**SECTION 00 9111
ADDENDUM NUMBER 1**

DATE: July 21, 2016

RSMP Phase 2A
James Monroe High School
RFI LOG
7/21/16

DRAWING REFERENCE NUMBERS: A343
 DRAWING NUMBER: ADDSK-A-01

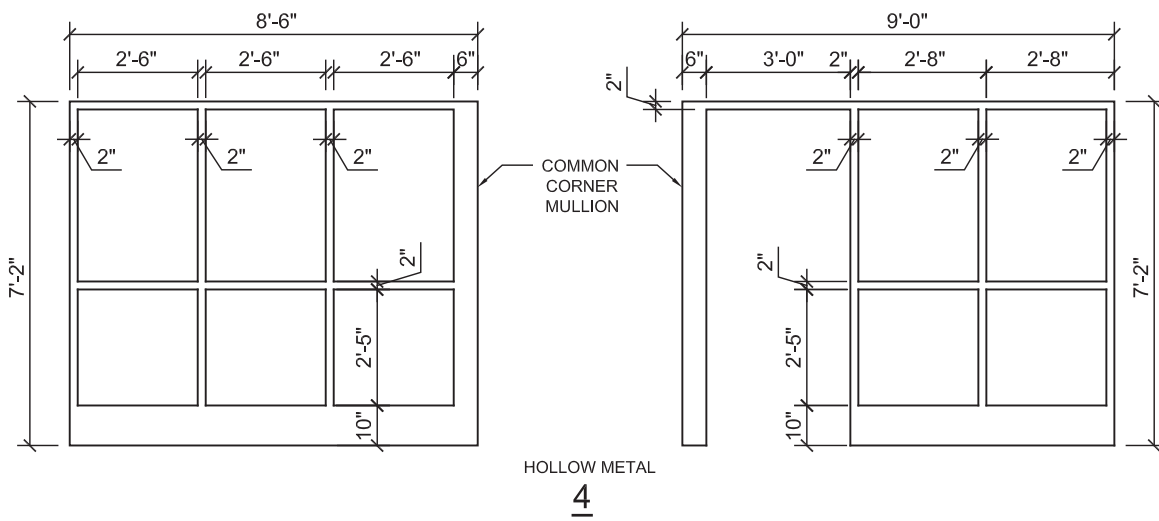
A343 – HEALTH SUITE PLAN, ELEVATIONS, AND DETAILS

- A. See sketch ADDSK-A-01 for correct room numbers and door numbers in HEALTH SUITE PLAN.
